**MEETING OF THE
DESIGN REVIEW BOARD
QUASI-JUDICIAL PUBLIC HEARING**

February 1, 2022

Subject: Site Development Plan Application
Proposed Multifamily Residential Development (35 DU)
10270-90 East Bay Harbor Drive
Bay Harbor Islands Acct. No. SPR21-00013
MMPA Acct. No. 01-0702-1112

Subject: Site Development Plan Application
Proposed Multifamily Residential Development (31 DU)
1165 - 1175 97th Street
Bay Harbor Islands Acct. No. SPR21-000022
MMPA Acct. No. 01-0702-1121

L.100

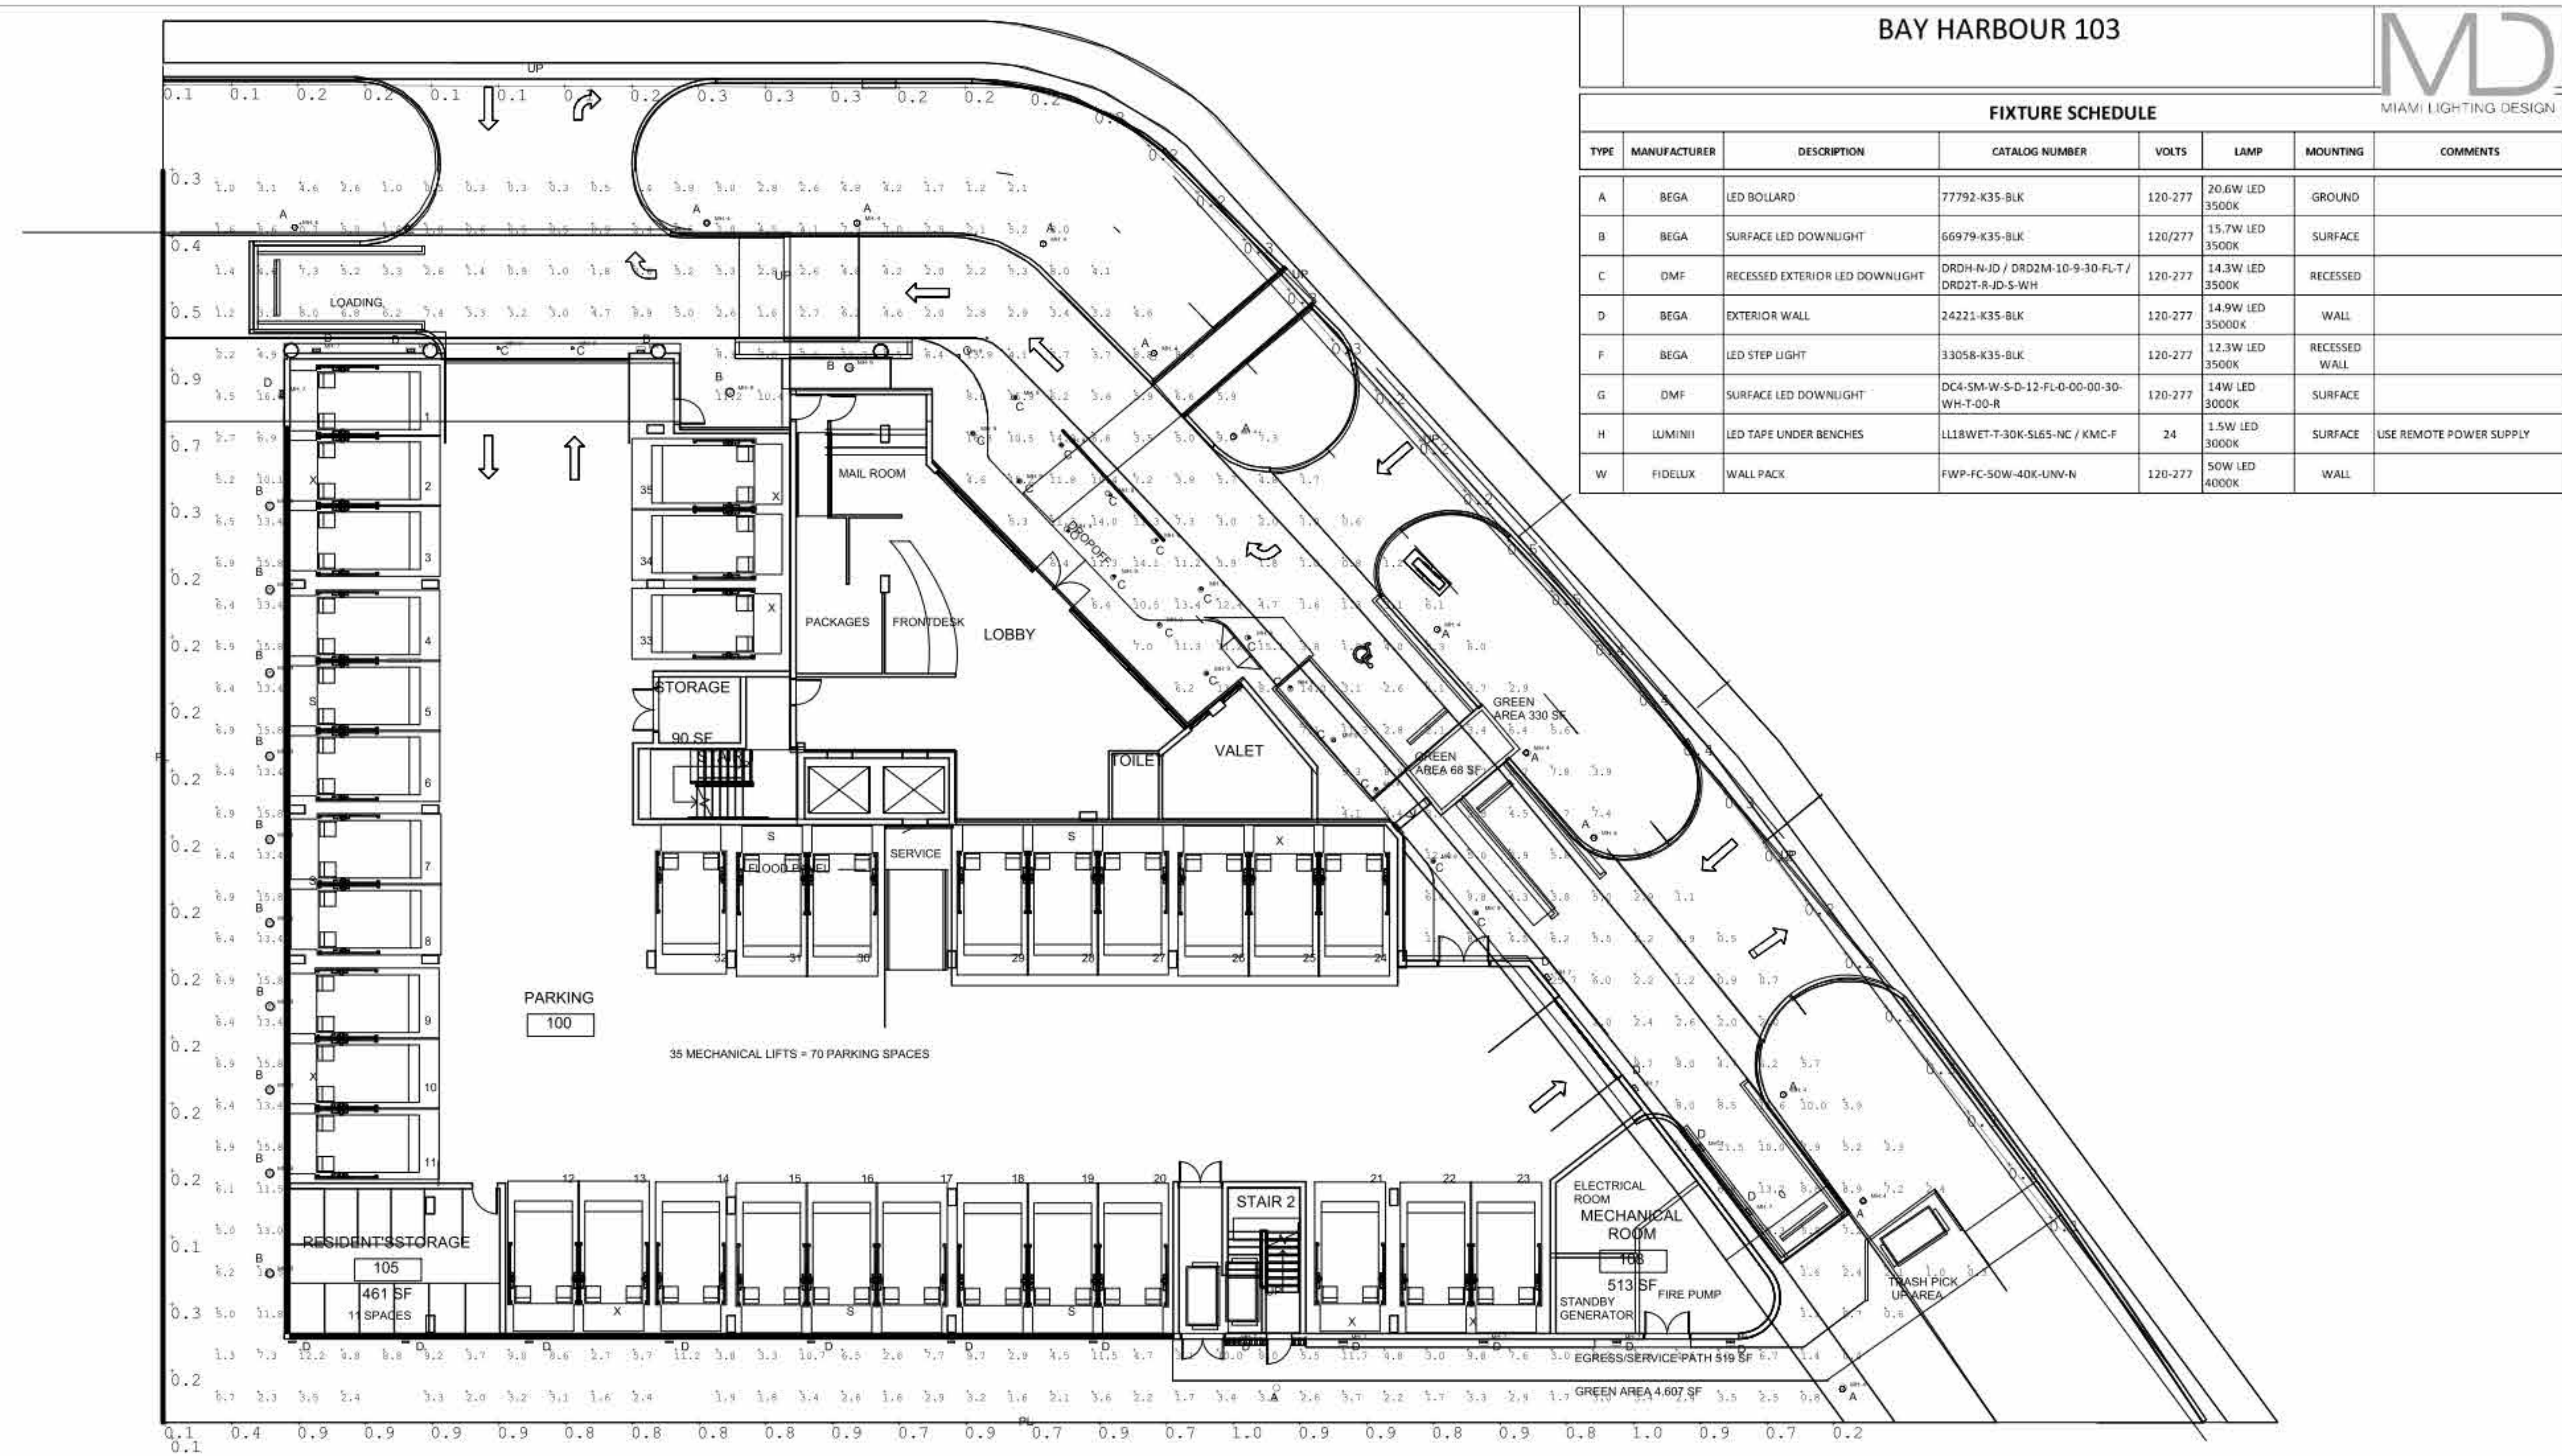
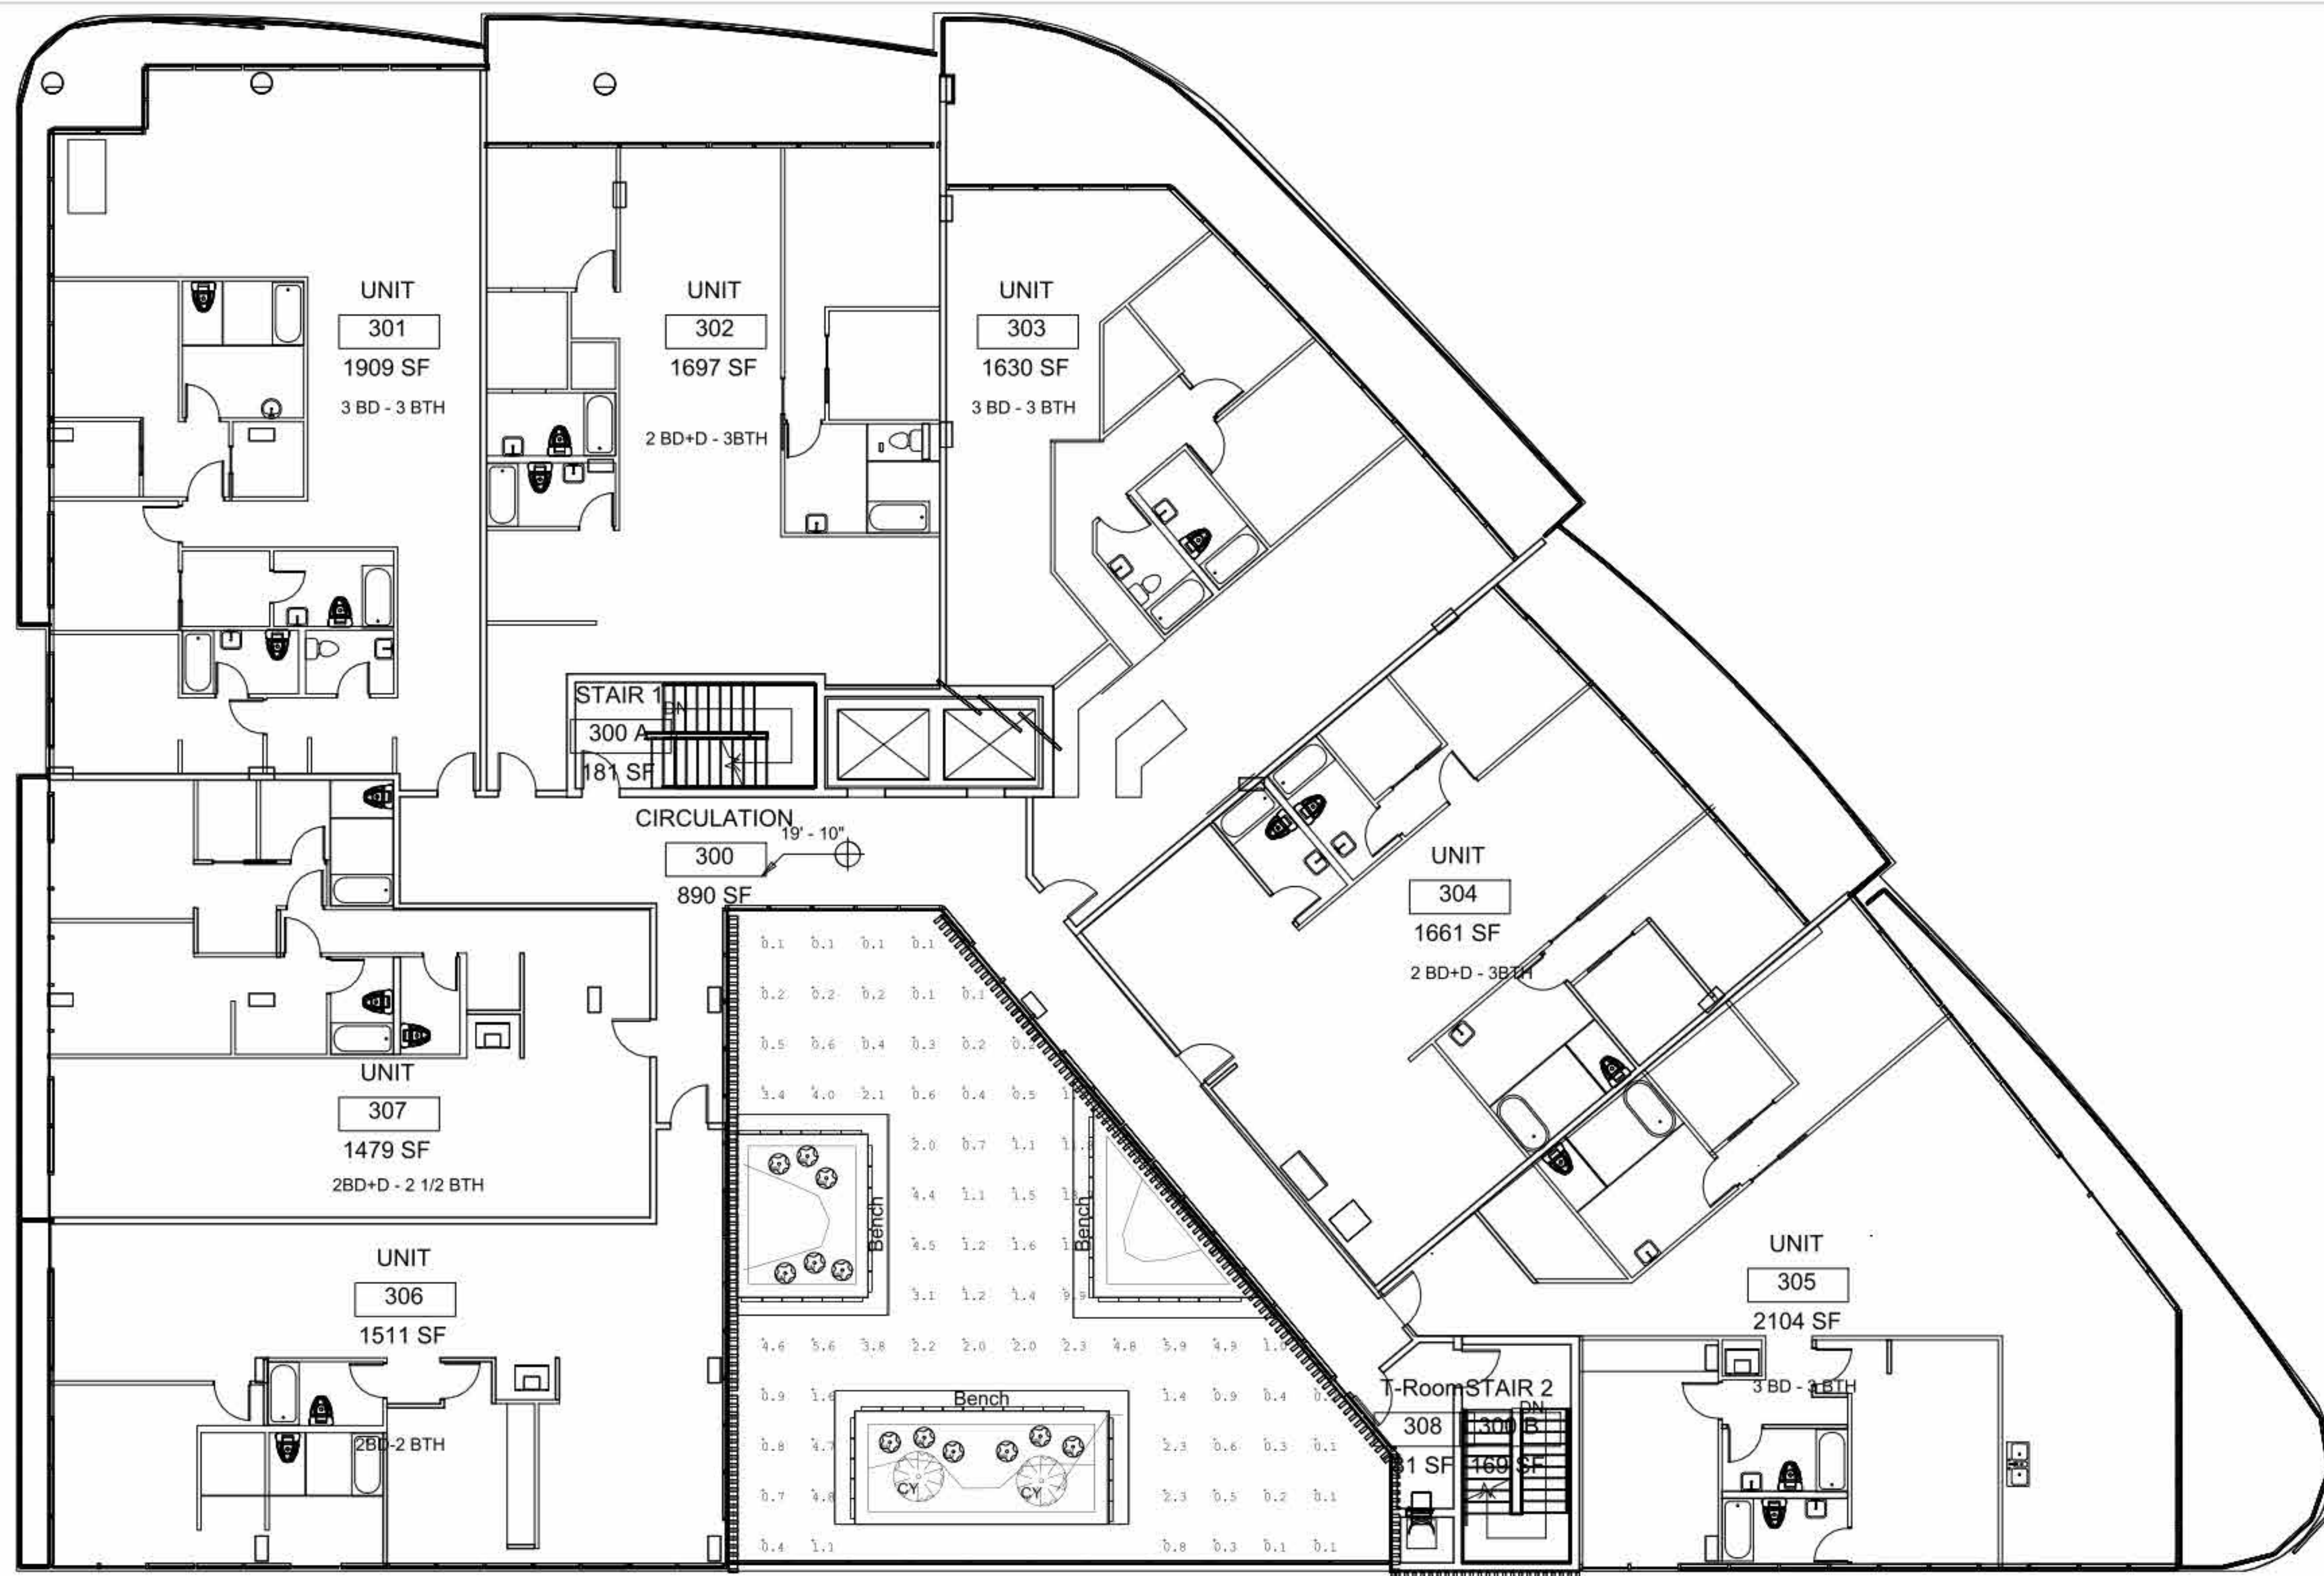
7. Outdoor Lighting Plan - The preliminary Photometric Lighting Plan shows general compliance with the Town's Exterior Lighting Code requirements found in Sec. 23-19. At the time of building permit review the Town staff will ensure the final lighting plan complies with the Code footcandle limitations / requirements.
